WEST BAY
SANITARY DISTRICT
SAN MATEO COUNTY, CALIFORNIA

FLOW EQUALIZATION AND RESOURCE RECOVERY FACILITY LEVEE
IMPROVEMENTS PROJECT
Menlo Park, California

ADDENDUM #3

WBSD Project No. 1762.0

SHEET
C2.0
 JOB NO.
1079

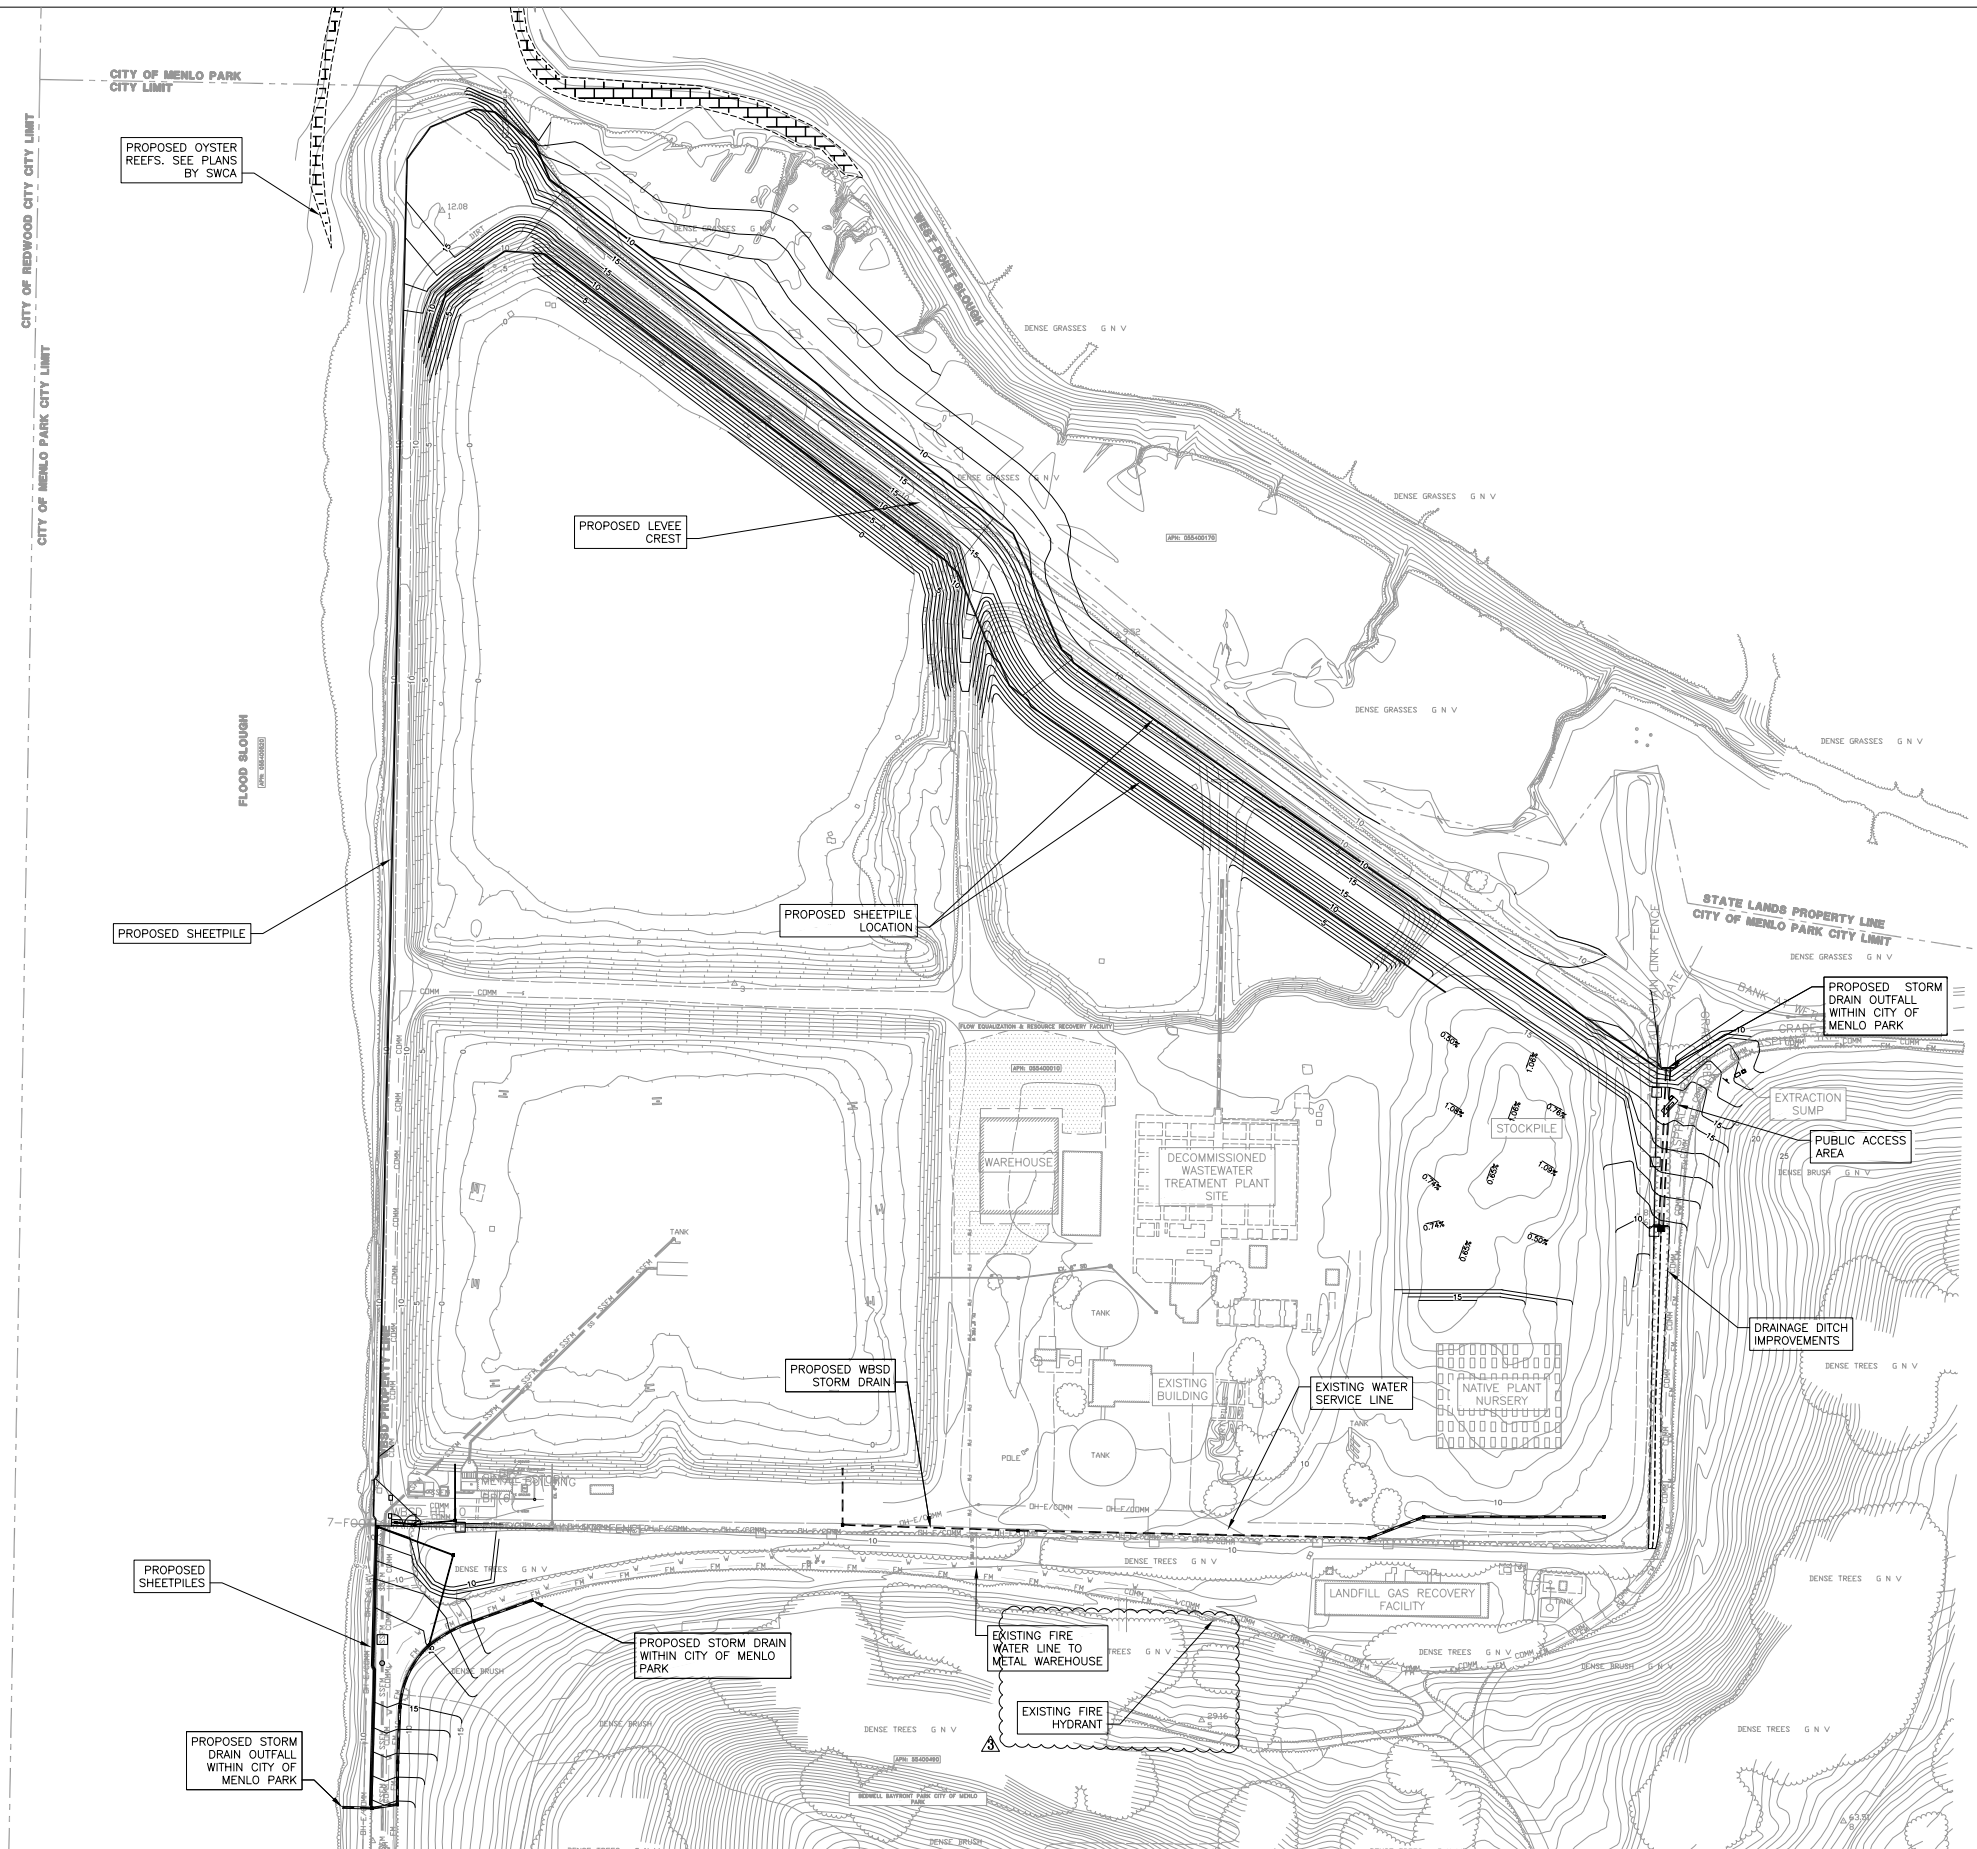
- a. A new point of connection is not needed. Contractors can get a fire hydrant meter from Menlo Park Municipal Water. Please see Sheet C2.0 for the location of fire hydrant.

REPLACE Pages C2.0 with C2.0 Addendum 3

SHEET
C8.1
JOB NO.
1079

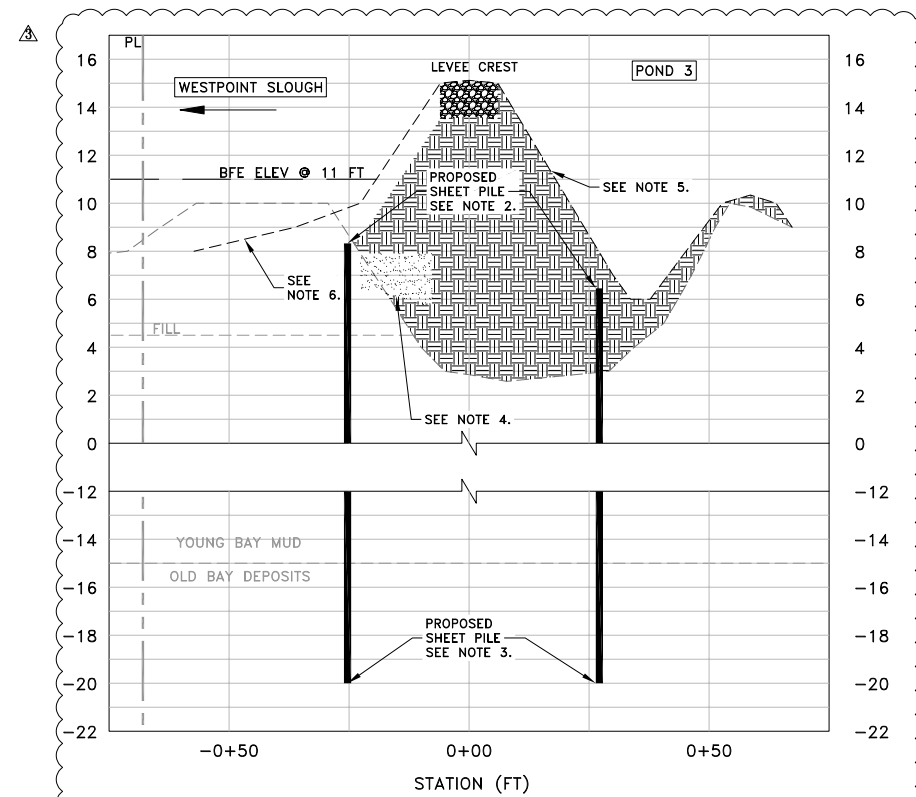
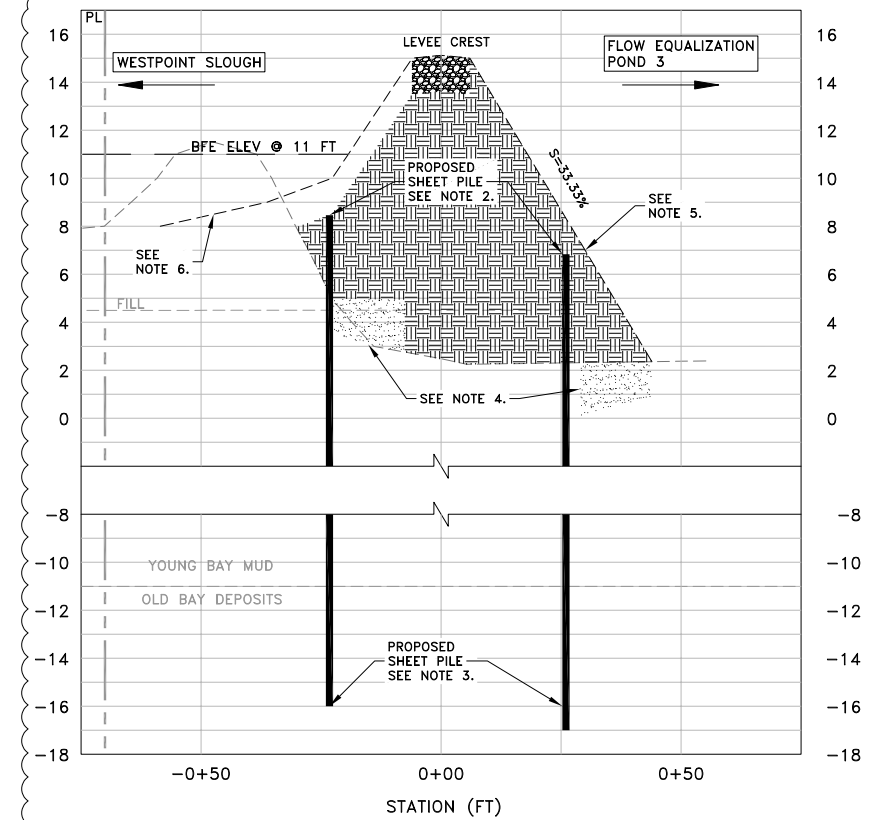
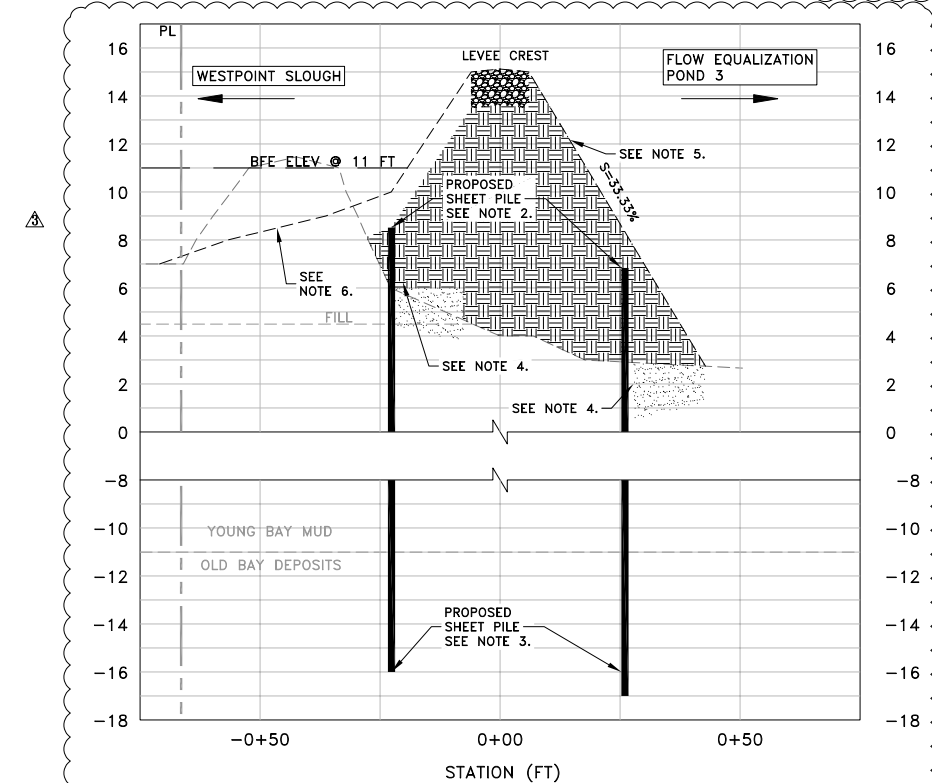
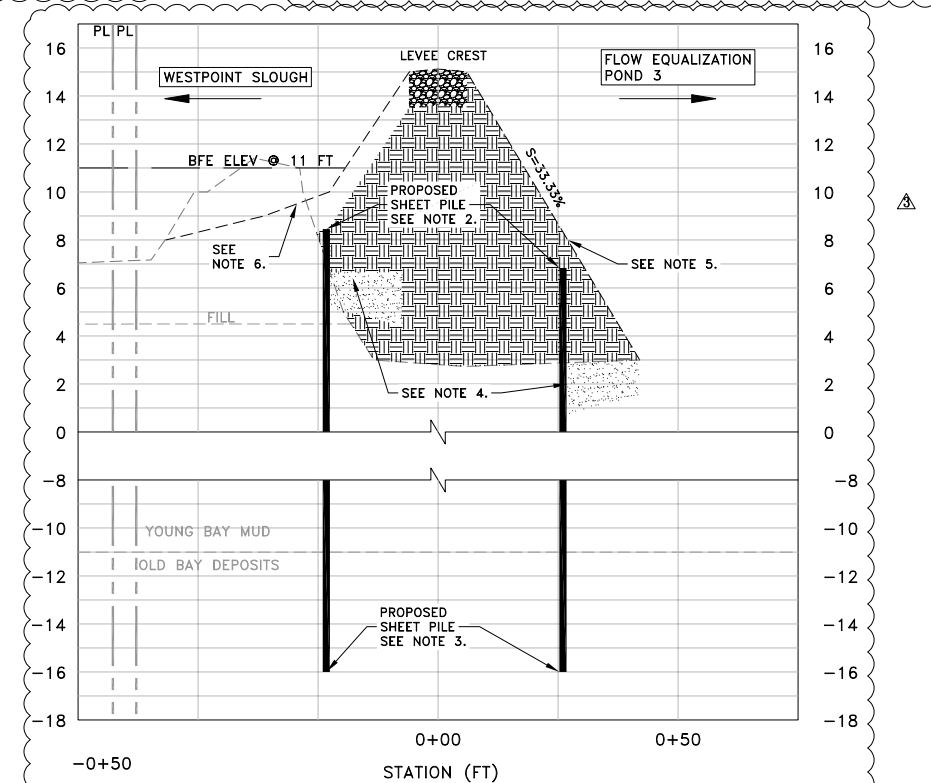
63. Sheet C7.1 & 8.1. Although the markings are very light and do not print out, they are visible on a large screen showing PDF. Most sections shown the flowable fill as a keyway for levee fill. Detail 6 shows Keyway flowable fill slough side (station 0+25) of sheet pile but not on far inboard (Station -0+50)? Detail 7 shows it only on inboard section (station 0+50) where there is no fill? Should this be Note 6?

- a. Please see revised sheets C8.1 and C9.1.

REPLACE Pages C8.1 and C9.1 with C8.1 – Addendum 3 and C9.1 Addendum 3
